COMMUNITY DEVELOPMENT
Planning & Zoning Division

SUBJECT: July 28, 2026 HISTORIC PRESERVATION COMMISSION MEETING

STAUNTON HISTORIC PRESERVATION COMMISSION**June 23, 2026****5:30 p.m.****Council Chambers**

HSF Recommendation

Historic Preservation District Certificate of Appropriateness Application

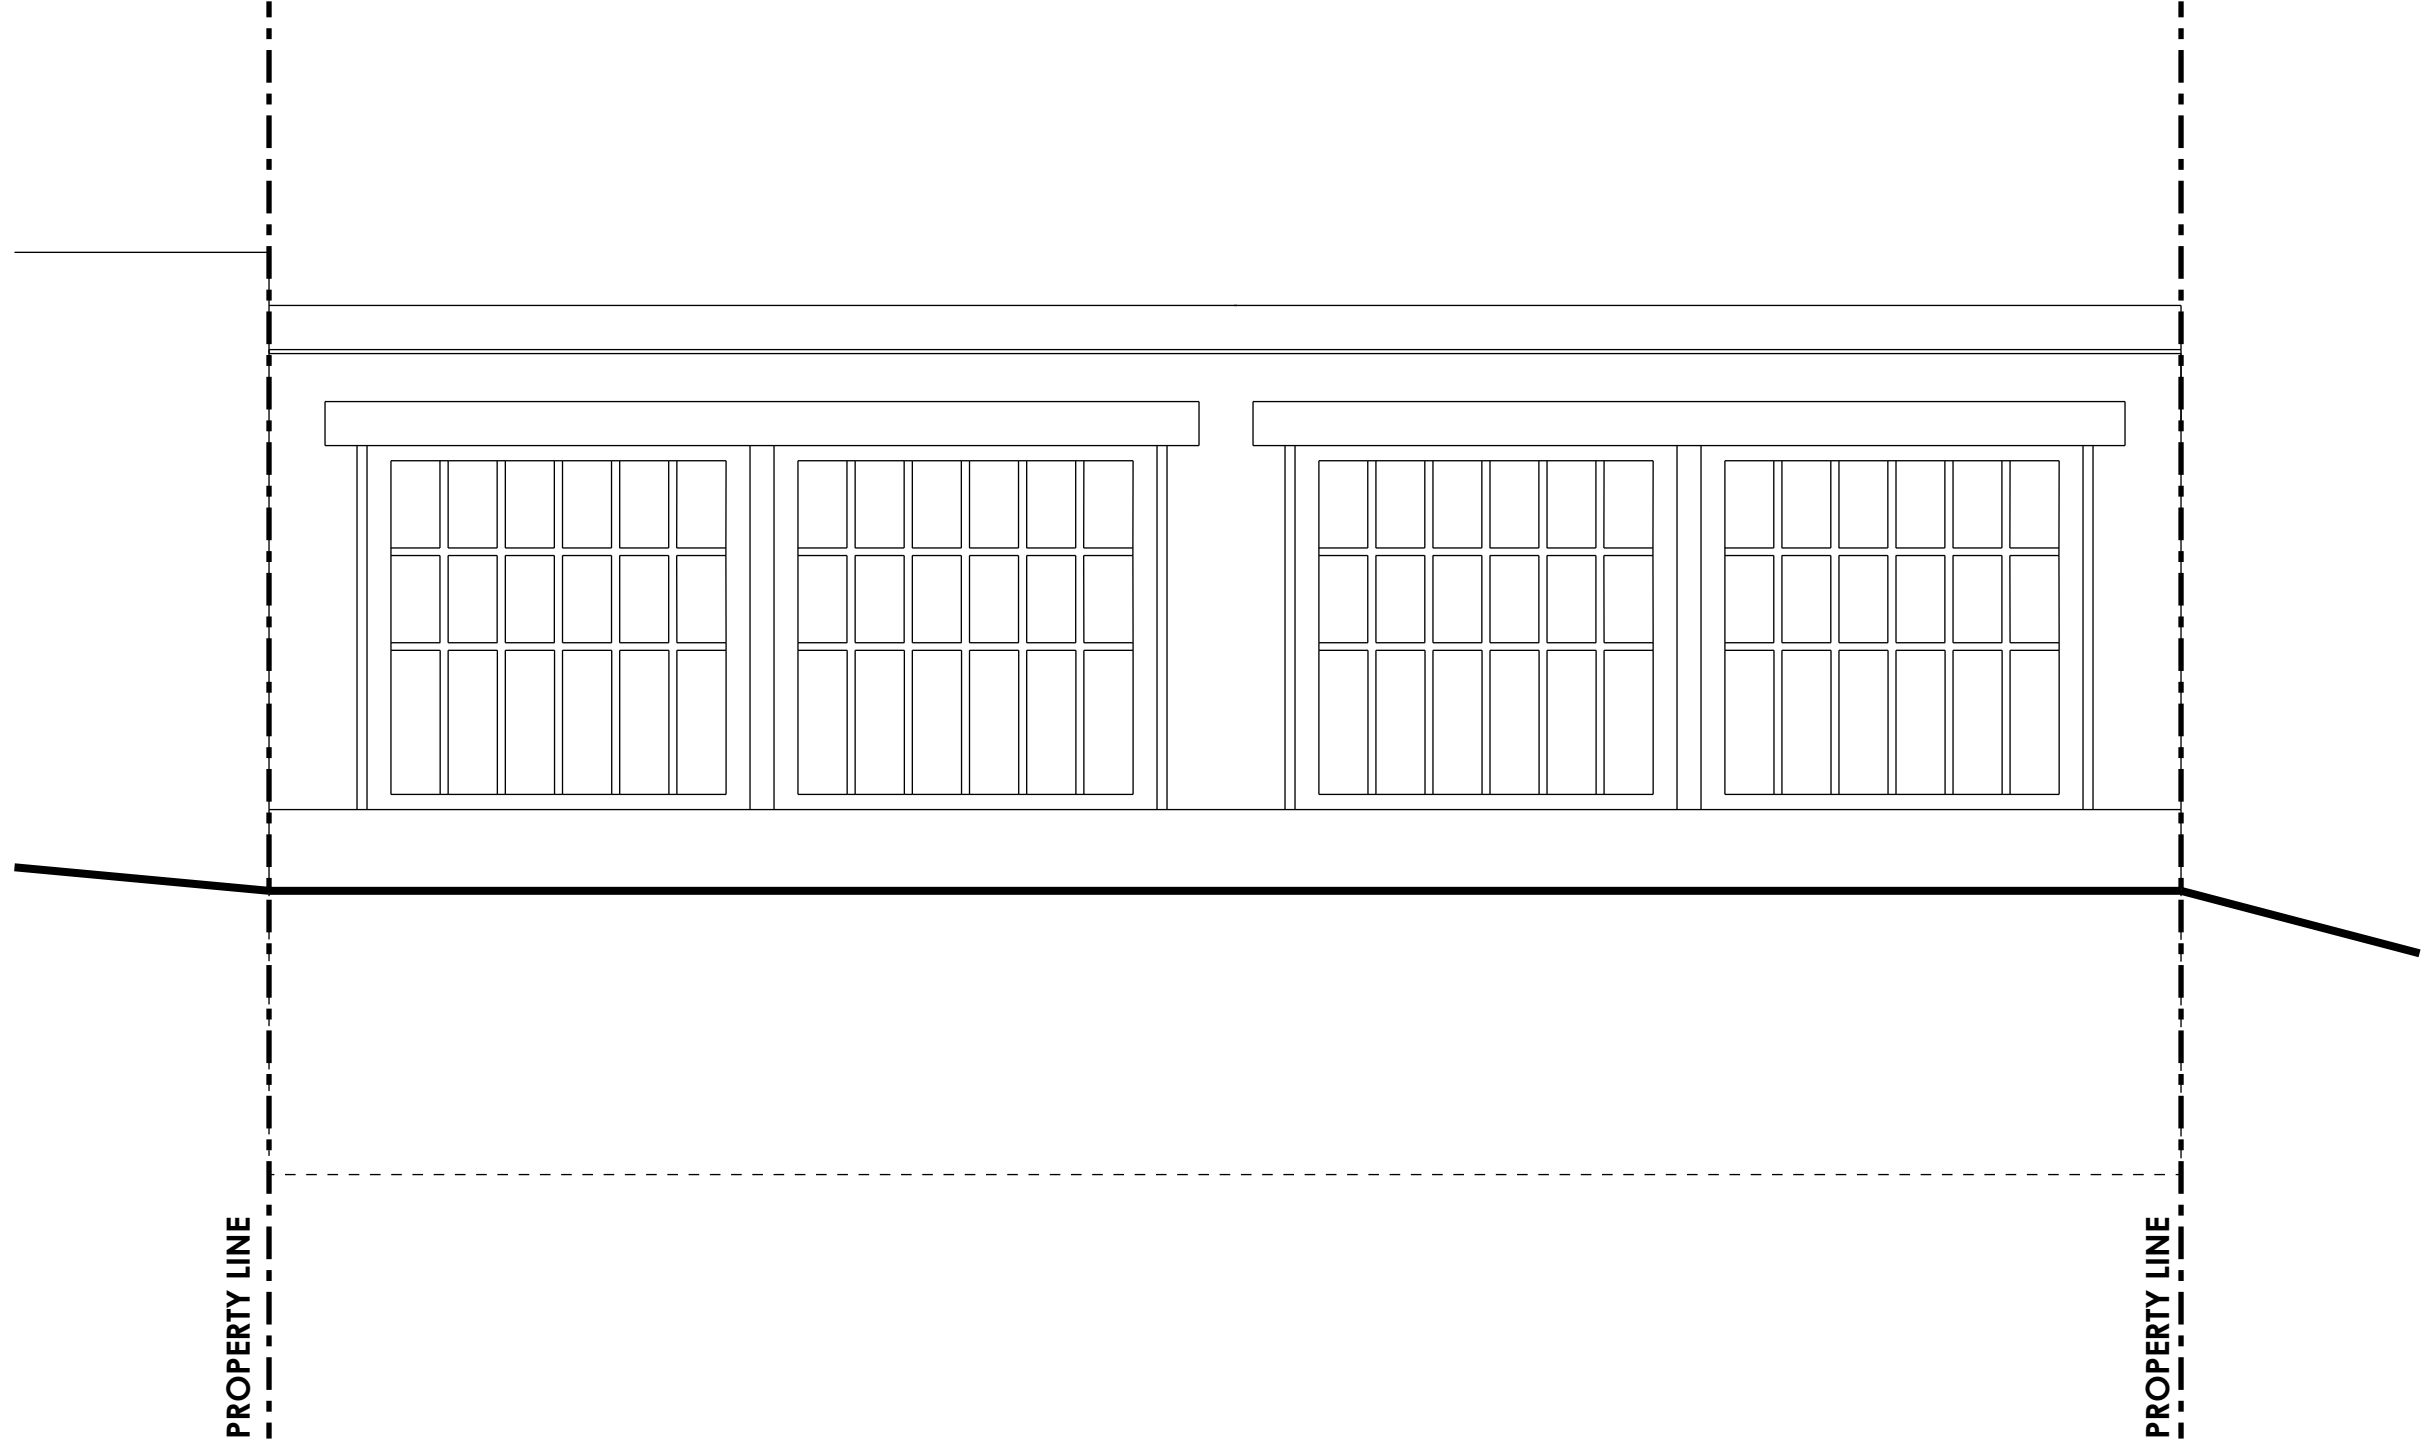
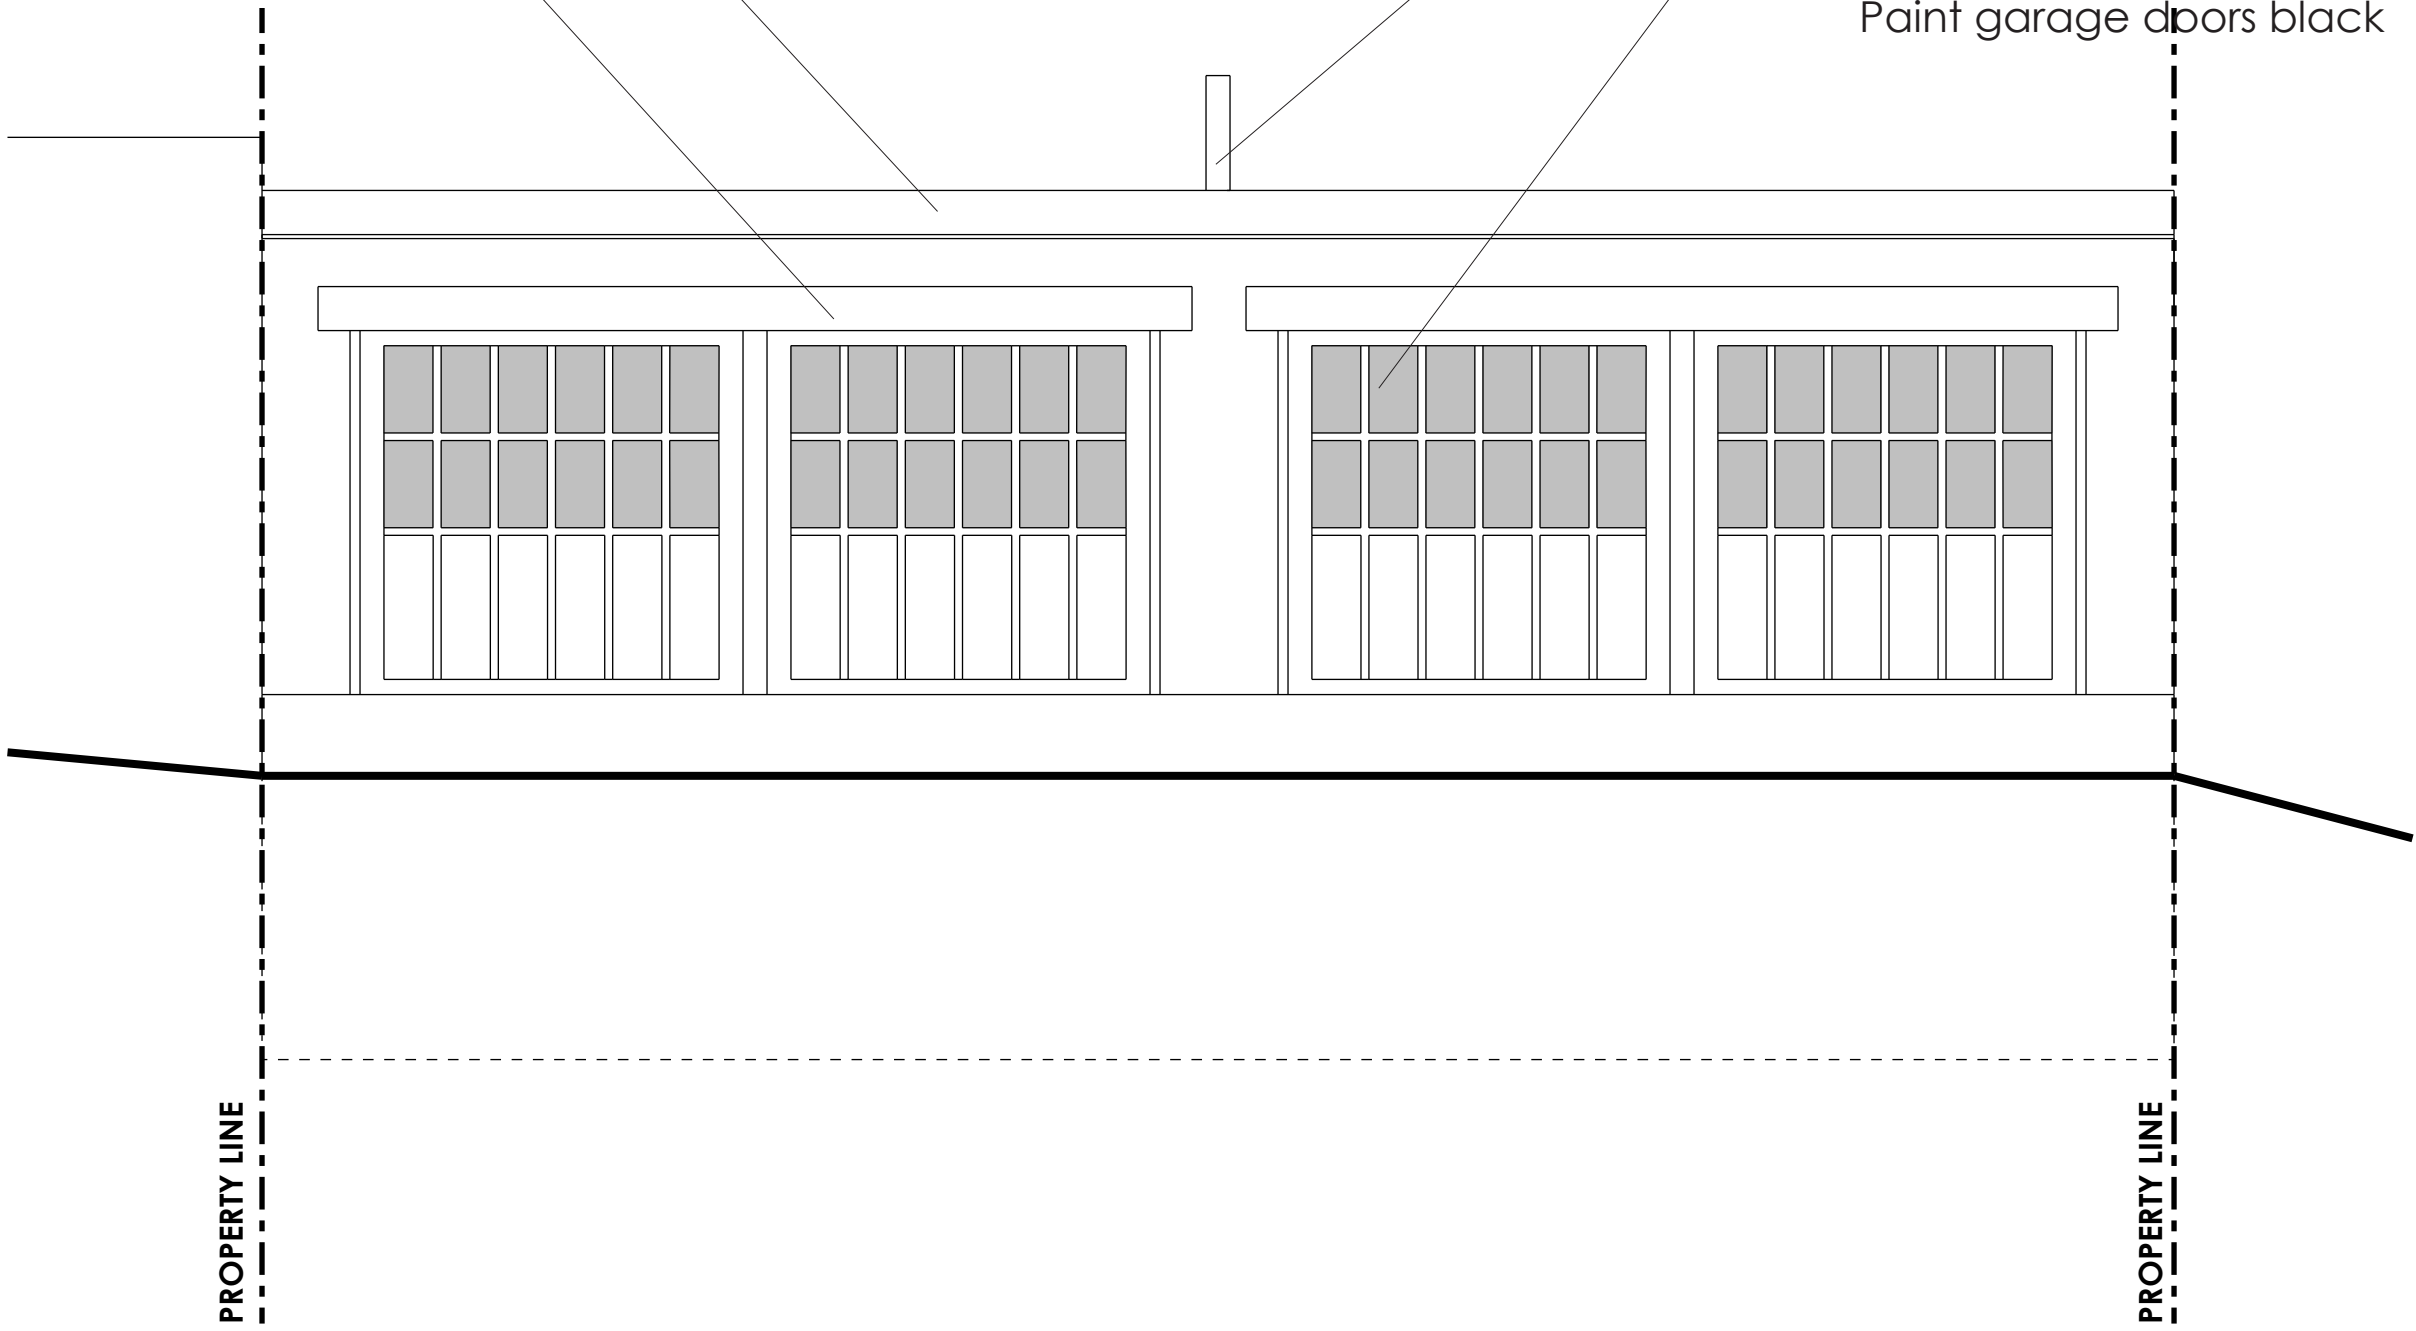
- Add glass panels to the top two rows of the existing garage doors.
- Paint garage doors black
- Add flue pipe for a new interior wood burning stove

- New Openings w/Black Aluminum Clad Windows + Doors
- Add a 3'x7' balcony to the East façade

- Replace the existing window on the South Facade with a new black aluminum clad window

The project involves renovating an existing brick garage. Most of the materials to be used will be existing. The brick will remain as-is. The existing fascia, soffit, garage doors and garage door header will be painted black. Windows and doors will be replaced with new black aluminum clad wood windows. A new steel balcony will added.

The rail and style construction with panels allow a retrofit of the upper panels with glass lights, reflecting the character of early 20th Century garage doors. Therefore, the change alters an existing replacement door by adding compatible glass panels.
